# Draft Urban Hamilton Official Plan Amendment No. XX

constitutes Official Plan Amendment XX to the Urban Hamilton Official Plan (UHOP).

The purpose of this amendment is to correct administrative (i.e. formatting, numbering, typographical and grammatical) errors. The effect of this Amendment is to improve clarity and understanding of the Urban Hamilton Official Plan.

### **EXCERPT FROM SCHEDULE C-2 - FUTURE ROAD WIDENINGS**

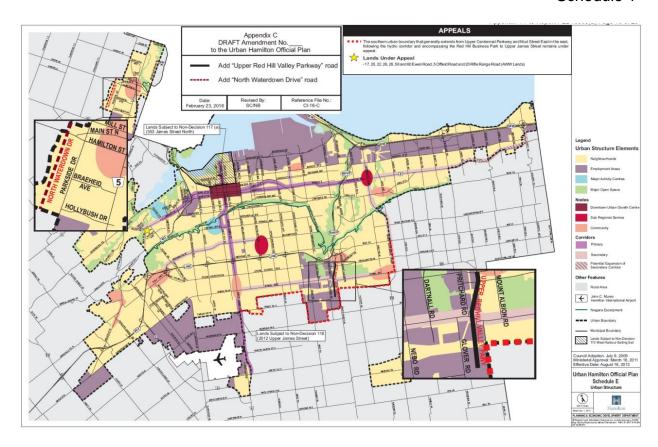
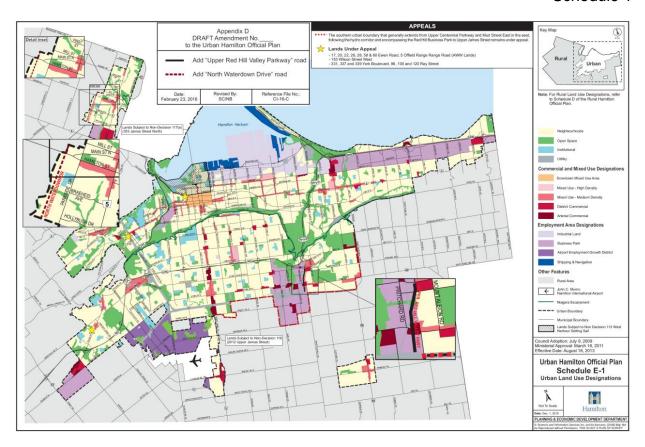
- b) Urban Hamilton Official Plan Schedule C-2 Future Road Widenings be amended by:
  - i. deleting the number "123" and replacing it with "213" in the Fiddlers Green Road Row:
  - ii. deleting the phrase "Proposed Trinity Arterial Corridor" and replacing it with the phrase "Upper Red Hill Valley Parkway" in the Highland Road Row;
  - iii. deleting the phrase "Trinity Church Arterial Corridor" and replacing it with the phrase "Upper Red Hill Valley Parkway" in the Trinity Church Arterial Corridor Rows; and,
  - iv. deleting the phrase "Trinity Church Arterial Corridor" and replacing it with the phrase "Upper Red Hill Valley Parkway" in the Trinity Church Collector Row;

APPENDIX B DRAFT Amendment No to the Urban Hamilton Official Plan			
Delete"123" and replace with "213"			
Delete the phrases "Proposed Trinity Arterial Corridor" and replace with the Phrase "Upper Red Hill Valley Parkway"			
Delete the phrases "Trinity Church Arterial Corridor" and Replace with the Phrase "Upper Red Hill Valley Parkway"			
Date February 25, 2016	Revised by: SC	Reference File No. CI-16-C
